**As-Built Baseline Monitoring Report**

**LITTLE SEBASTIAN SITE**

NCDMS Project # 100027 (Contract # 7187) | RFP 16-006993 (Issued 9/16/2016)  
USACE Action ID: SAW-2017-01507 | DWR Project # 2017-1041

RE: Little Sebastian Mitigation Site: Baseline Report and As-Built Drawings (NCDMS Project ID #100027)

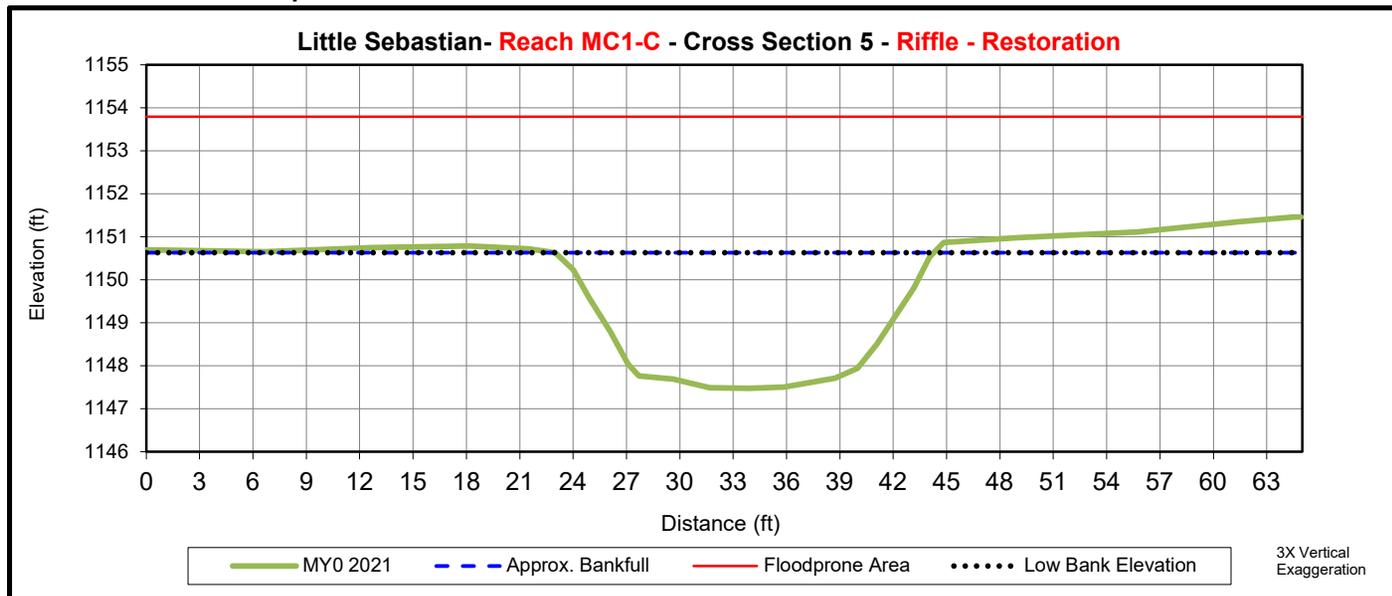
**Appendix D - Cross Section Sheets – Cross Section 4:** The cross section sheet notes that the reach approach associated with the cross section location is EII. The CCPV sheet notes EI. Please review and update as necessary.

The correct approach is EI. This has been updated in the report.

DRAWING TITLE:  
REACH MC1

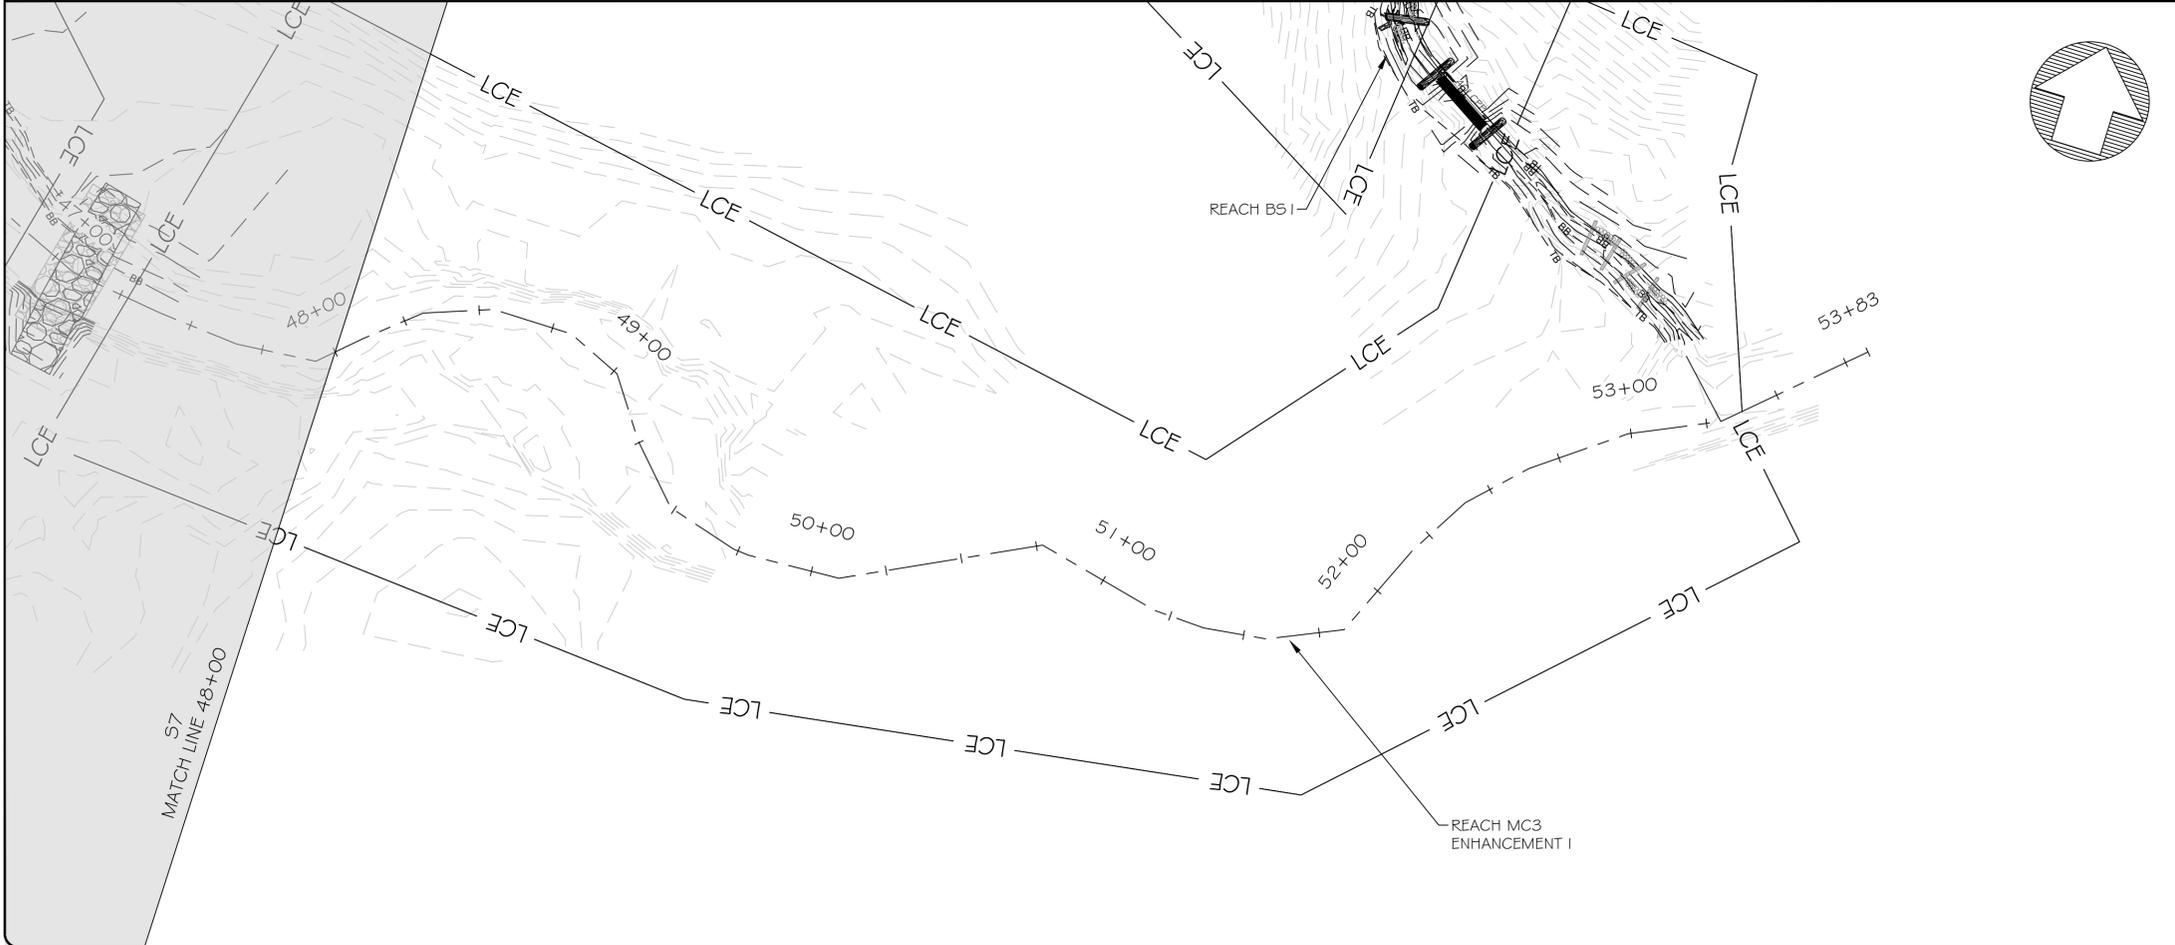
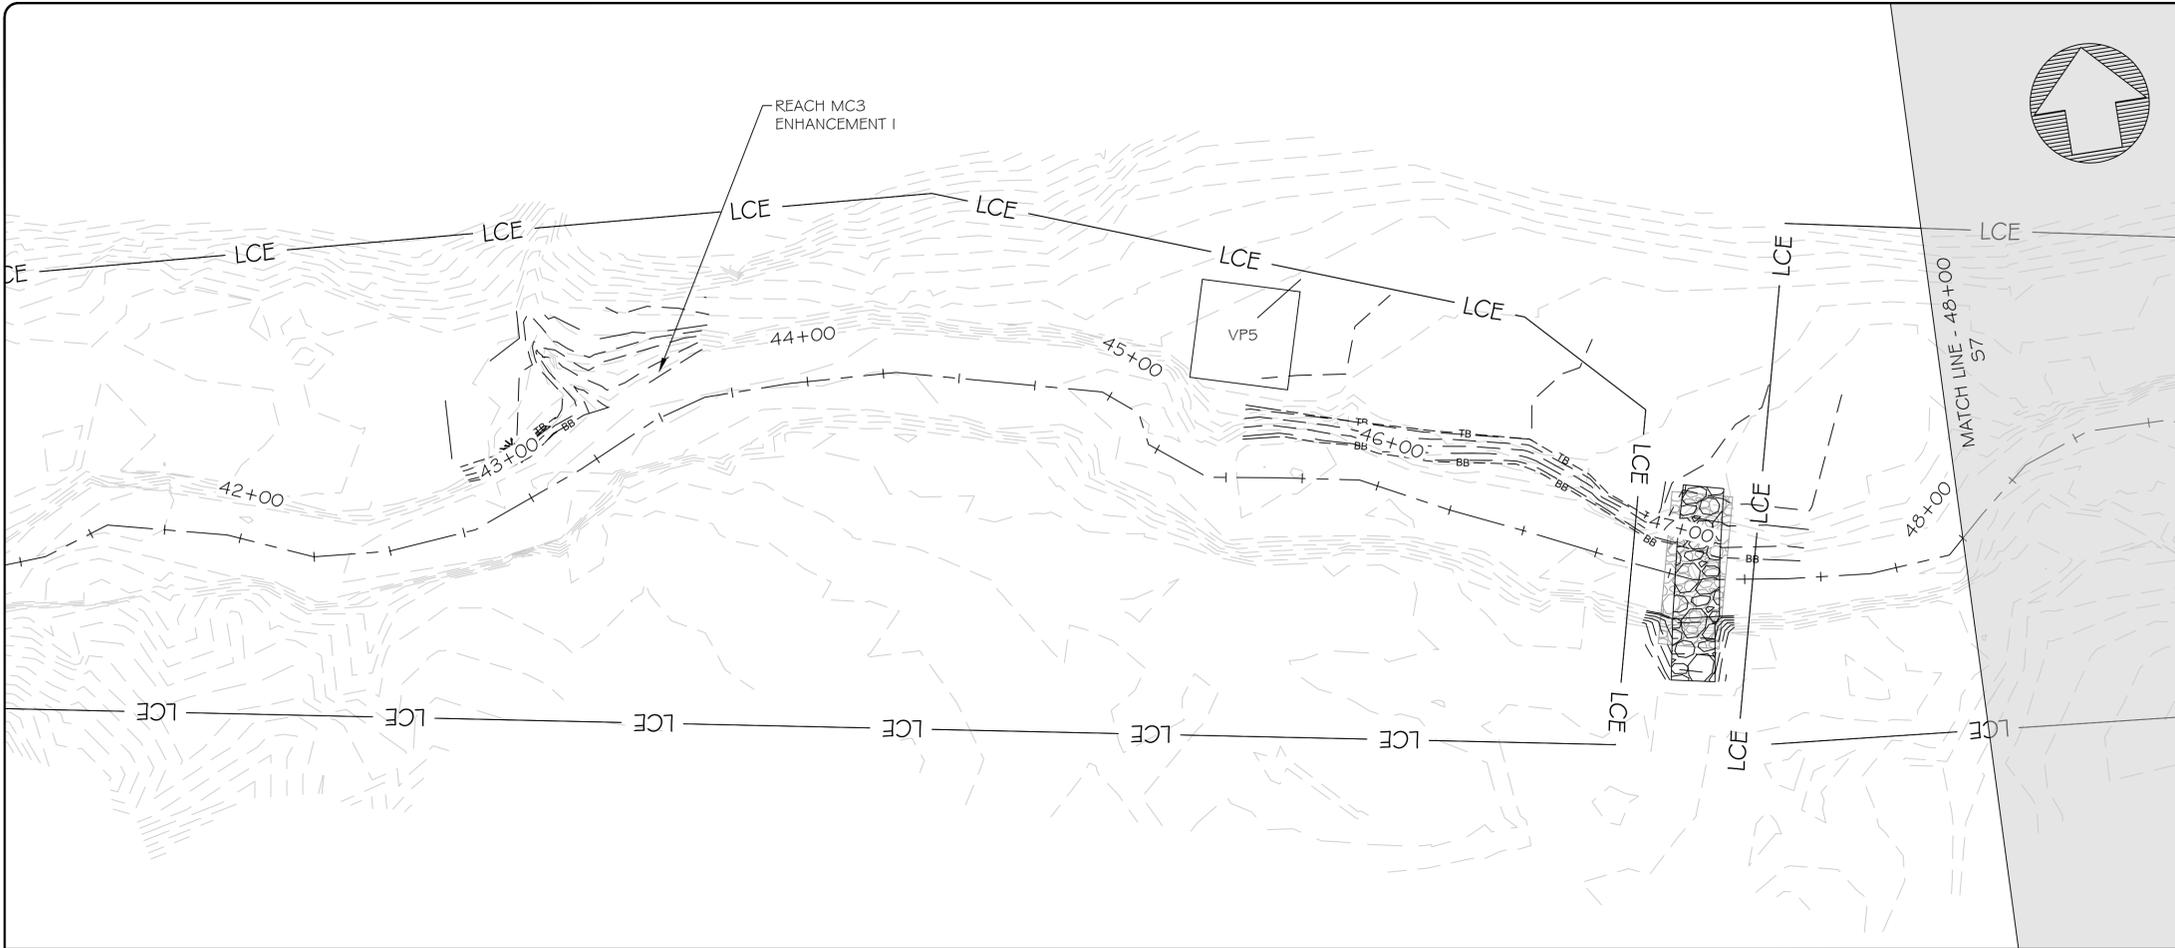
- The project conservation easement shown on the draft record drawings is identified as the Limits of Proposed Conservation Easement (LCE). The final recorded conservation easement (approved by the NC SPO) should be utilized for the record drawings. Please update the record drawings and legend accordingly. Once updated, please confirm that no areas of fencing or project crossings are located within the recorded conservation easement.

The record drawings have been updated with the recorded easement. Two areas of fencing within the easement were found on MC1 and will be removed by MY1.
